MEETING OF THE BOARD OF COUNTY COMMISSIONERS
BOULDER COUNTY
AGENDA

2.a [Public Hearing for Community Planning & Permitting Docket LU-24-0014: O'Connor Access Road](#)

STAFF RECOMMENDATION

Docket LU-24-0014: O'Conor Access Road

DATE: 08/23/24
JOB NO: 1000-9
CAD NO: 10009BASE
DRIVEWAY PLAN AND PROFILE

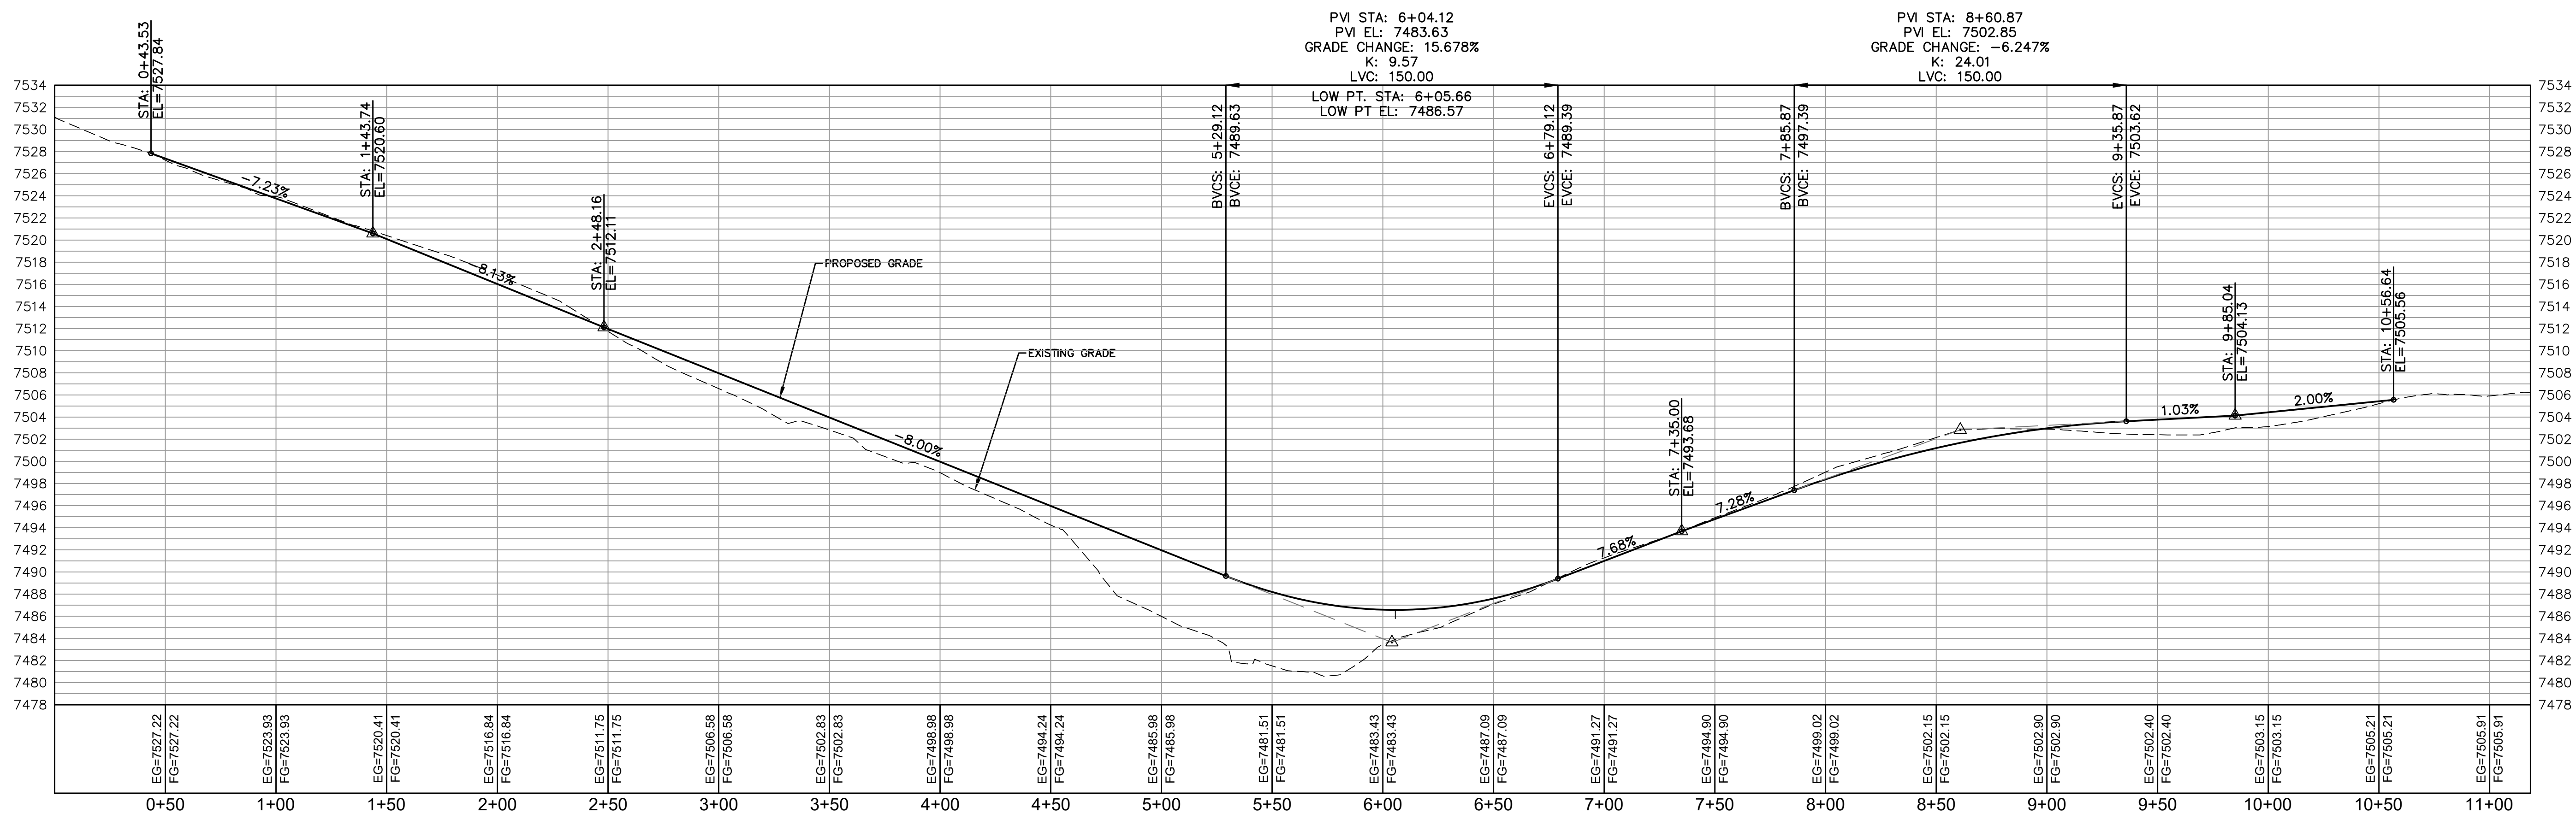
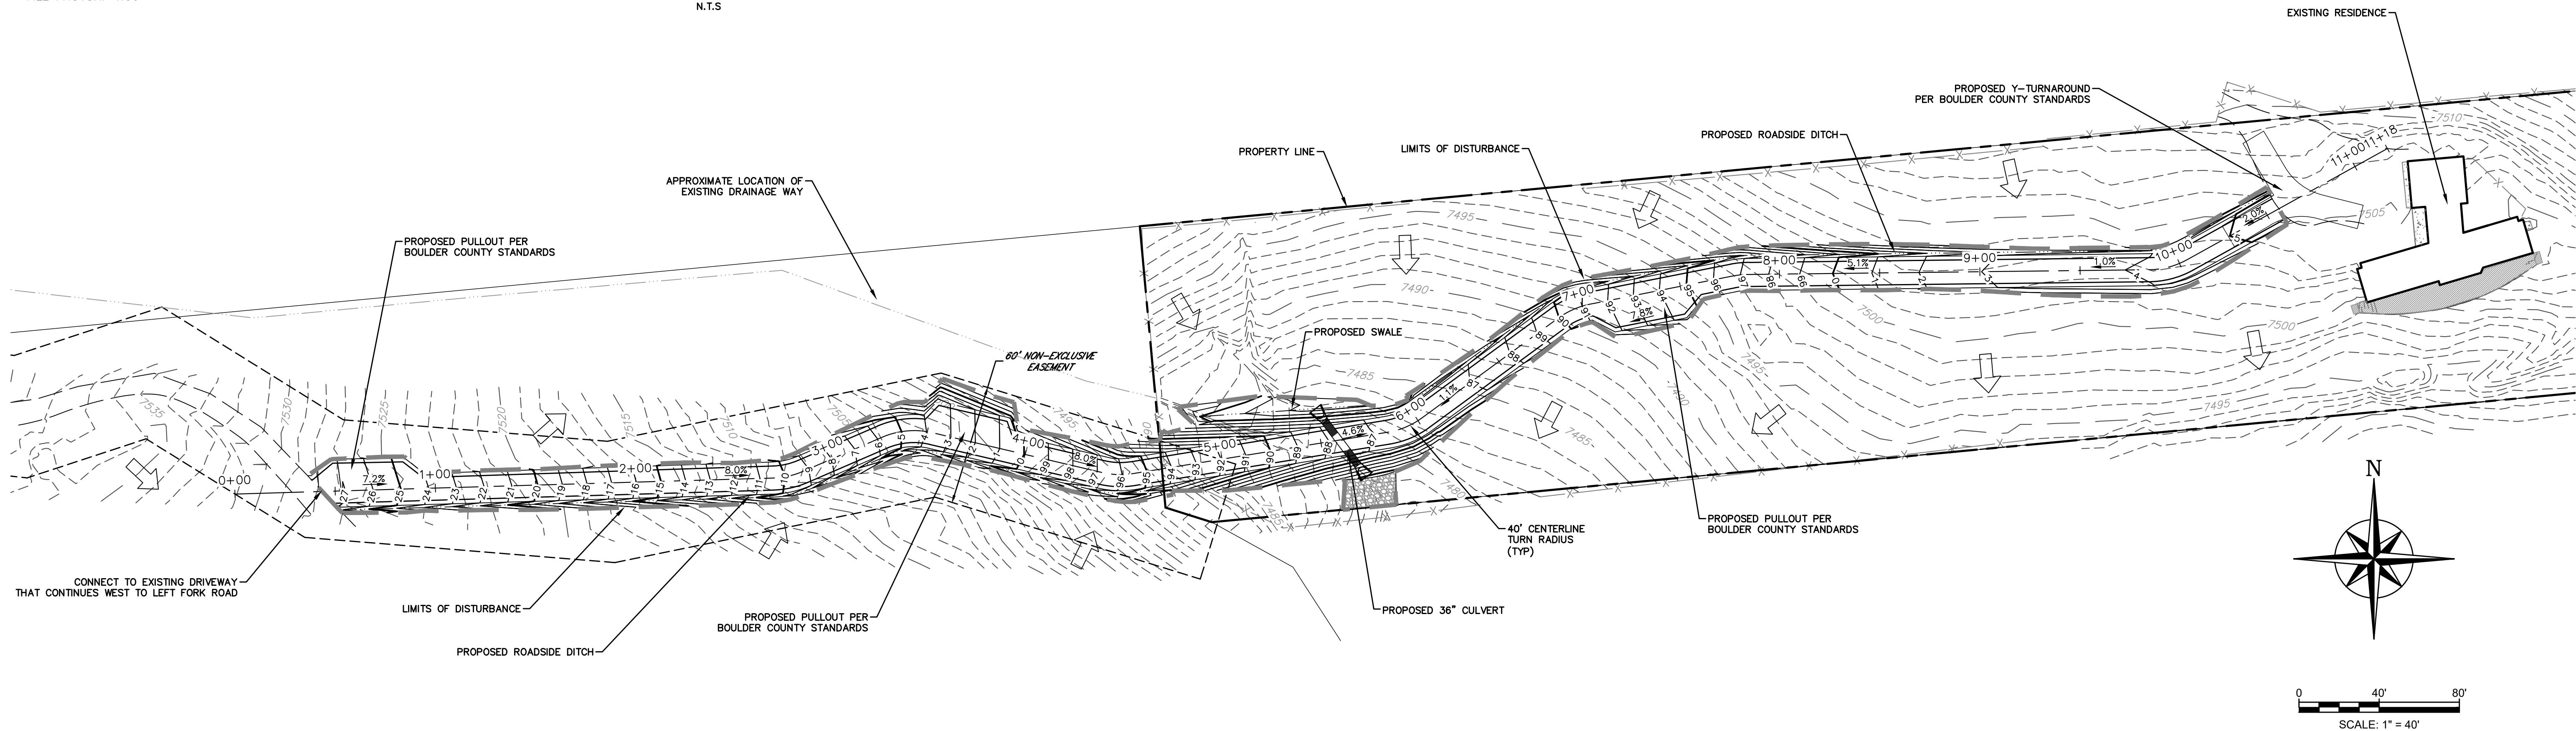
- a. At some points on the plan, the improvements are proposed very close to the easement and property line. The easement boundaries and property line should be staked between Stations 4+00 and 6+00 of the road alignment to ensure no grading or placement of riprap occurs beyond the easement and subject property.
- b. The pullout beginning at approximately Station 3+50 incorporates tapers that do not meet the Standards.
- c. The radius of the “Y” turnaround appears to exceed the required 30-foot radius.

At building permit, submit plans that comply with the Boulder County Multimodal Transportation Standards.

OVERALL DRAINAGE, GRADING, AND EROSION CONTROL PLAN

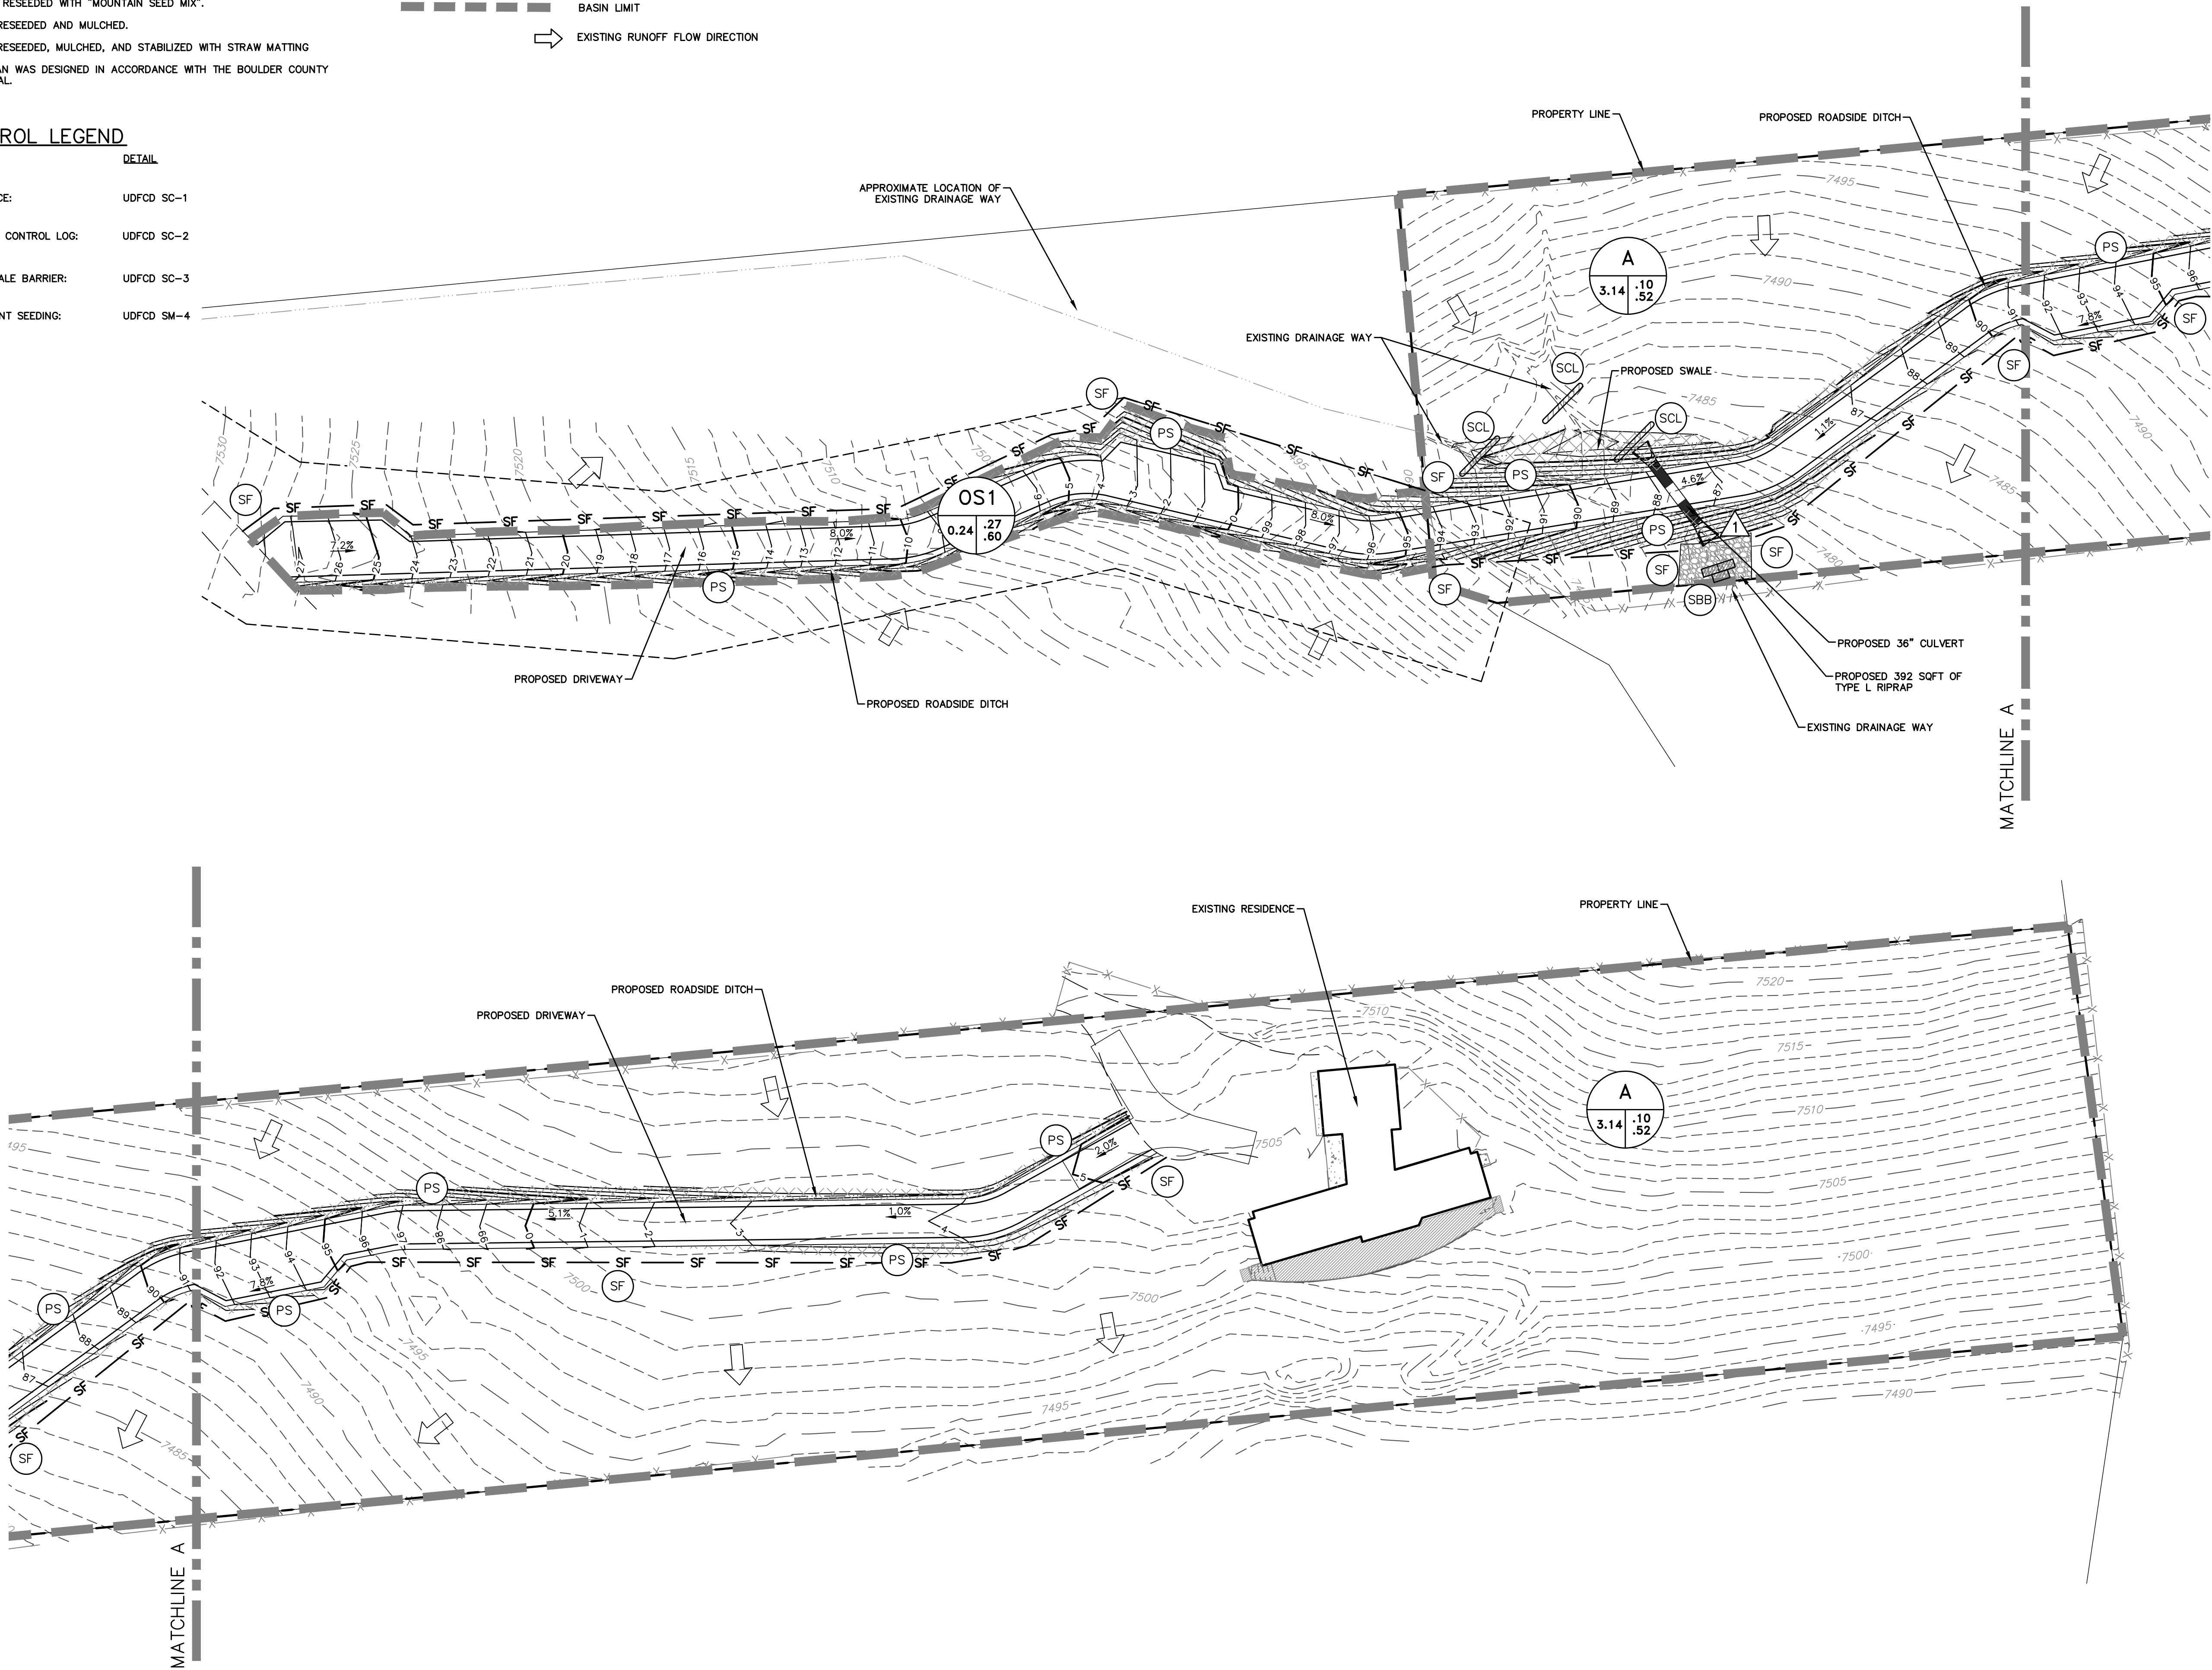
Staff anticipates that the proposed construction of the new access road could change the overall pattern of drainage and recommends that the historic offsite drainage rate be regulated to no more than pre-development rates or potentially lower to offset the effects of the increased runoff volume and concentration of flow to prevent the worsening of the existing erosion channel.

Staff recommends a condition of approval requiring a revised drainage letter that addresses the concerns outlined in the Boulder County Development Review – Access & Engineering referral that is included on pages B4 and B5 of Attachment B.

Figure 1

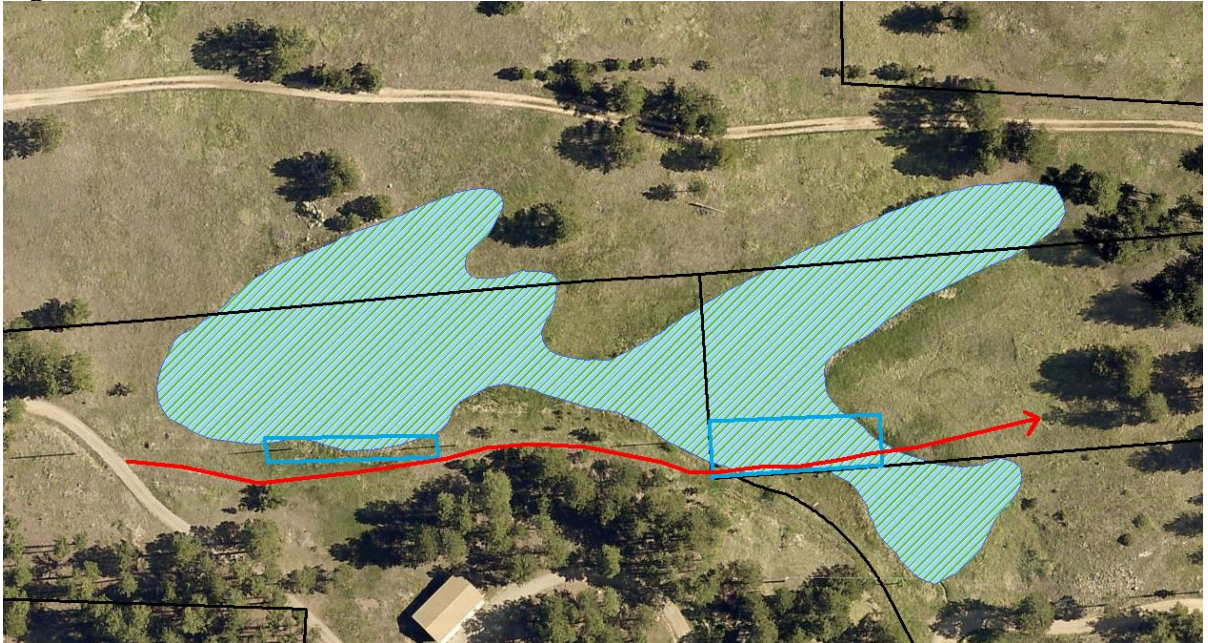
About the first half of the new driveway (western end) would be on the adjacent parcel, in upland and on a previously disturbed, old road grade. This portion should not result in significant impacts as long as construction on the northern edge of the drive does not enter the wetland area on the north (see fencing requirement below; and Figure 1, blue polygon on west.)

Staff notes that the Comprehensive Plan wetland mapping includes an automatic “buffer” on known wetlands. On Figure 1, a more accurate boundary of the wetland is presented.

For the eastern end of the new driveway, in upland, there also should not be significant impacts. However, in the middle of the driveway, the alignment crosses a drainage and wetland area. This site is staff’s main concern – blue polygon on east in Figure 1.

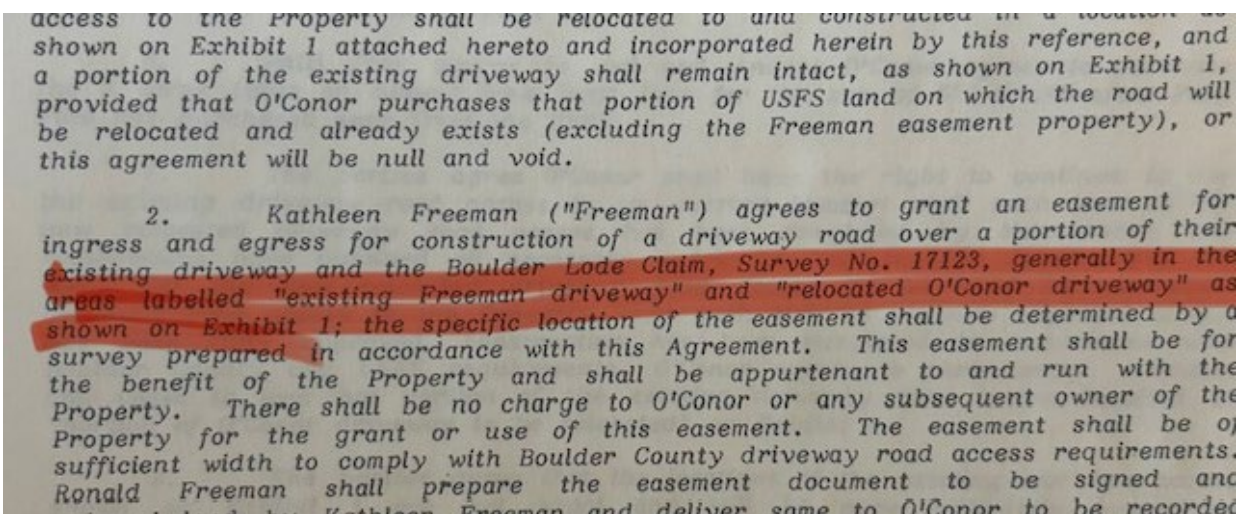
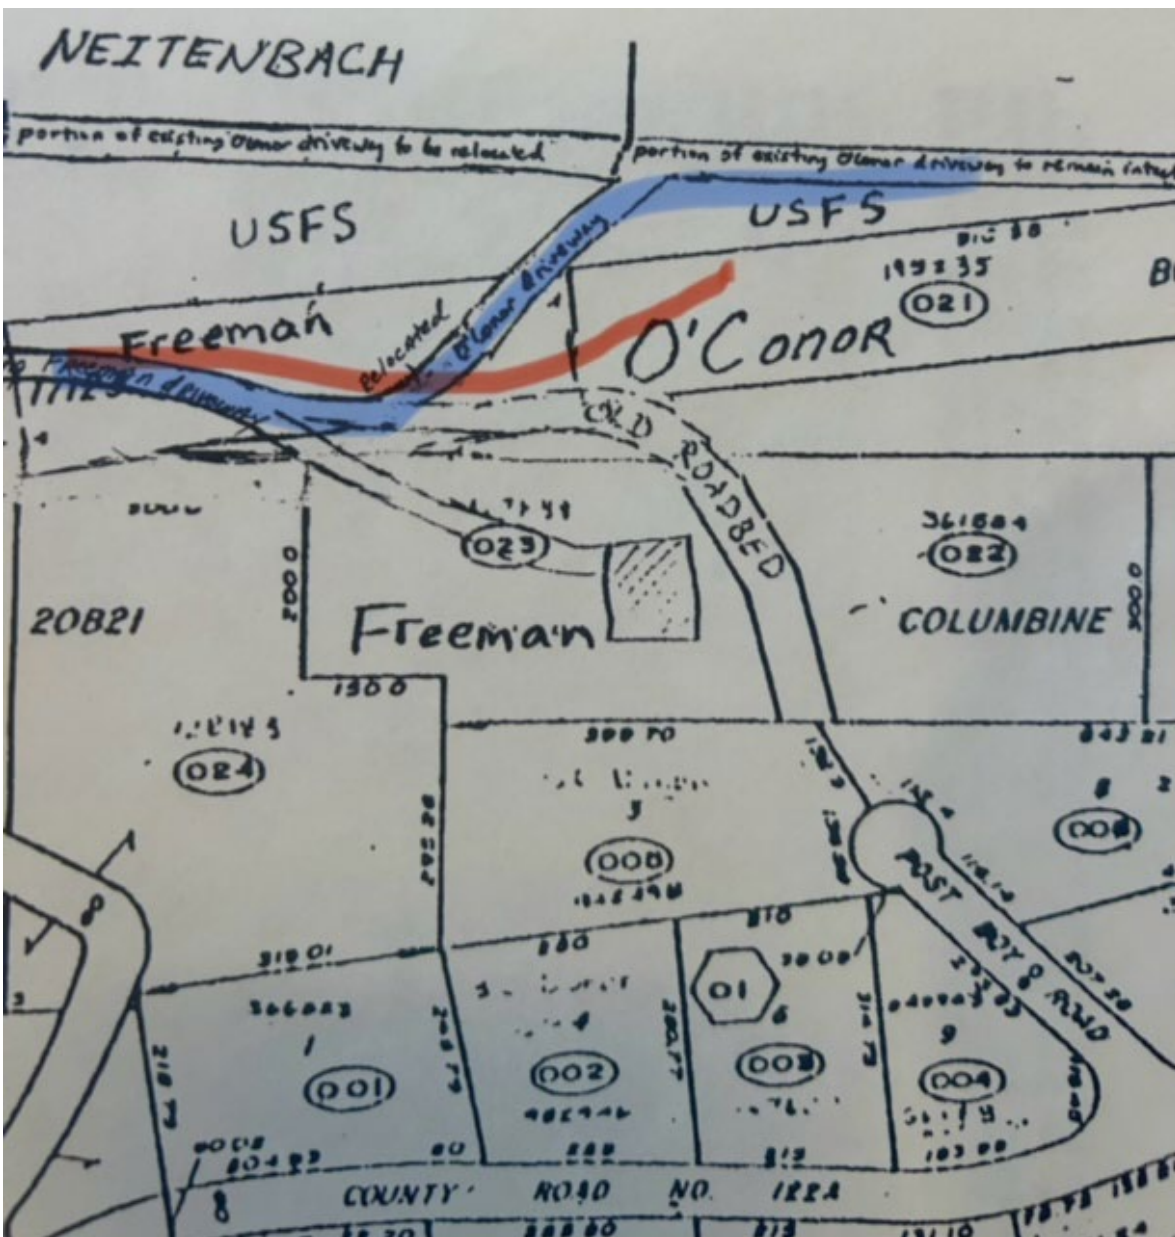
Interestingly I noticed on the Memorandum of Agreement/easement paperwork from when it was granted by my mom Kathy (written up by my dad-he was very sick and passed away soon after so put it in my mom's name) the map showed a different path for the construction of a driveway which is not where the surveyor stakes are located. The easement map called for the road to be north of the heart of the meadow, not the low point/center of it, sparing several trees and lots of water/peat.

(The Orange lines are the Surveyors stakes). Interested in what the environmental/ biological: geotechnical engineer /Parks Open Space opinion is?
